Technical Letter Report  
on  
PNNL Review of Farley Unit 2 Submittal  
on EOC Voltage Distributions,  
Burst Pressure Probabilities and Leak Rate

Prepared for  
Office of Reactor Regulation  
U.S. Nuclear Regulatory Commission  
under Contract DE-AC06-76RL0 1830  
NRC JCN E2029

Enclosure 2

Figure 1: Distributions of projected EOC 11 voltages.

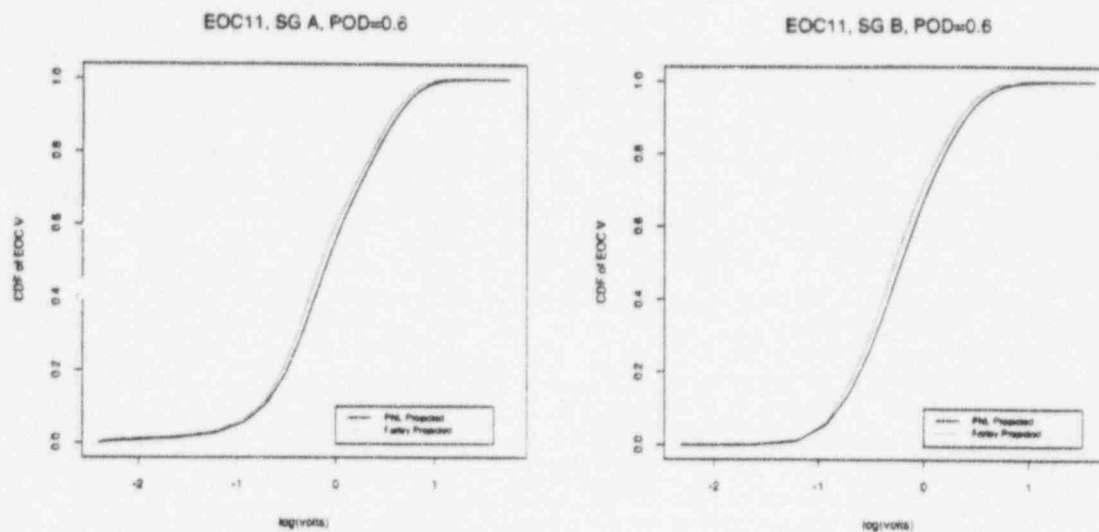
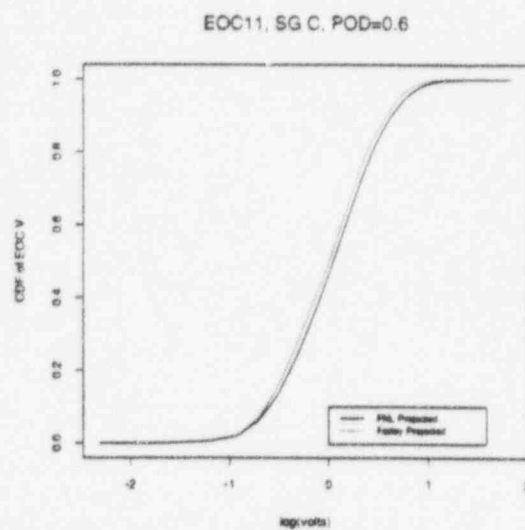
The Farley Unit 2 projected EOC 11 bobbin voltage distributions were given in Tables 7-3 in [1]. PNNL's corresponding projections together with Farley Unit 2 projections are presented in Figure 1 and Table 1. As can be seen from the results, Farley Unit 2 calculations agree well with PNNL's even though all the PNNL distributions are slightly larger than the Farley II distributions.

Figure 2: Comparison of Projected and Actual EOC 10 Voltage Distributions for SG C

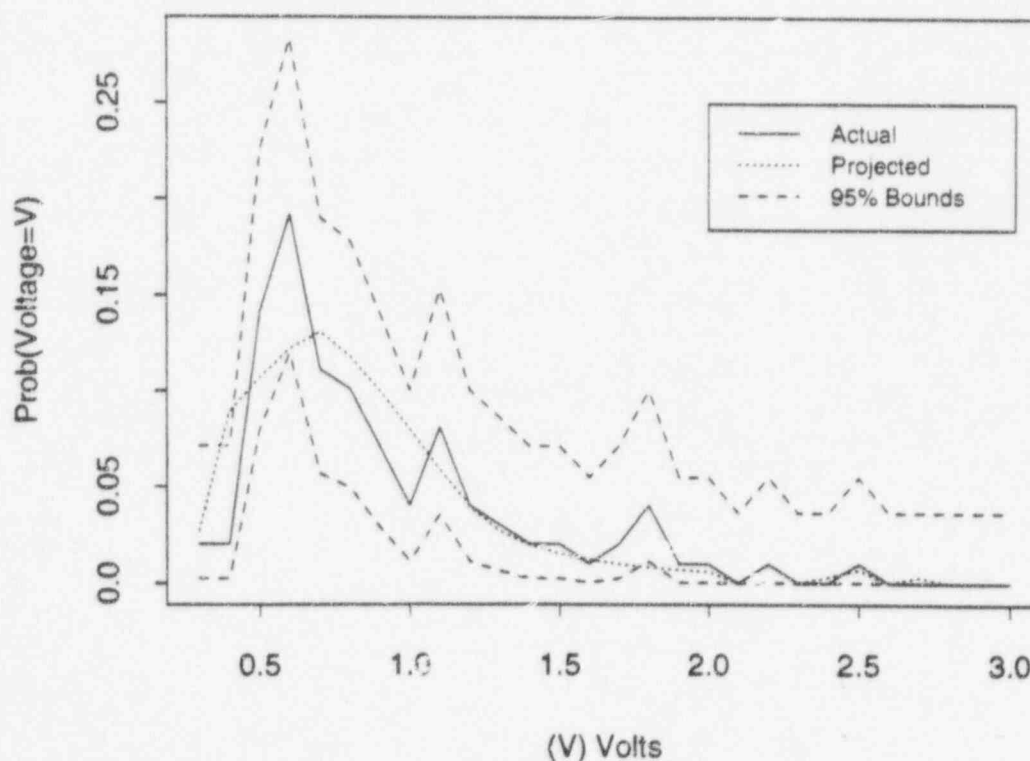
Figure 2 presents a comparison of the projected with actual EOC 10 Voltage distribution for SG C. These results were extracted from Table 7-1 in [1]. The actual distribution in this plot has been surrounded by 95% confidence bounds, which describe the amount of variability one would expect in an estimate such as this when it is being estimated from a sample of this size. These particular confidence bounds do not describe the sizing and detection inspection errors that might be present within the actual distribution. Nevertheless, the confidence bounds give a gauge that can be used to compare the two distributions.

As one can see from the Figure, the projected distribution generally falls within the 95% bounds, indicating general agreement between the projected and actual distributions. These results show that the strategy of using the voltage growth rates from the previous cycle gives a good prediction for the next cycle.
